BULLETIN

NUMBER 53

SUBJECT: Fuel Shut-Off Swivel Fitting

MODELS AFFECTED: J3, Serial Nos. 5535, 5547, 5601, 5607, 5608,
5609, 5612 to 8175.
J5, Serial Nos. 5-784 to 5-1384

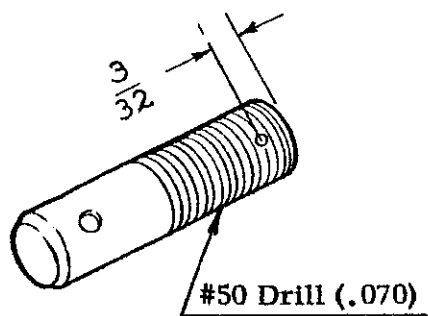
We have received a number of reports of failure of the fuel shut-off control attachment at the swivel fitting.

Apparently the lockwasher does not positively prevent the nut from becoming loose and, in the cases reported, this has allowed the control wire to slip out of the fitting, with the result that the fuel shut-off could not be operated.

We, therefore, recommend that the plain nut and lockwasher be replaced with a shear nut (AN320-3) and cotter pin (AN380-2) as shown in the attached sketch.

It will be necessary to drill the stud with a No. 50 drill (.070) to accommodate this cotter pin.

Upon re-assembling this attachment, care should be taken that the control wire is drawn well into the fitting recess. The free end of the wire should then be straightened to be parallel with the main section as shown in sketch.
